## **Product Change Notice (PCN)**

PCN Number: PCN-0450899R-01

Product(s) Affected: SJ1-4251X Series. SJ1-42514, SJ1-42515TS & SJ1-42516

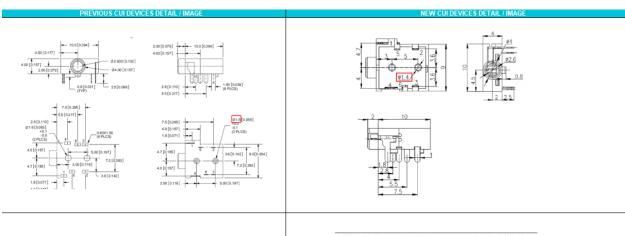
Description of Change: Locating pin difference and material change. See image Below

MATERIAL	PLATING
terminal 1	copper alloy	gold flash
terminal 2	copper alloy	gold flash
terminal 3	copper alloy	gold flash
terminal 4	copper alloy	gold flash
terminal 5	brass	gold flash
terminal 6	brass	gold flash
plastic	PA66

DESCRIPTION	MATERIAL	PLATING/COLOR
terminal 1	phosphorous bronze t=0.25	gold flash
terminal 2	phosphorous bronze t=0.20	gold flash
terminal 3	phosphorous bronze t=0.20	gold flash
terminal 4	phosphorous bronze t=0.25	gold flash
terminal 5	phosphorous bronze t=0.20	gold flash
terminal 6	phosphorous bronze t=0.20	gold flash
housing	PA66 (UL94V-0)	black
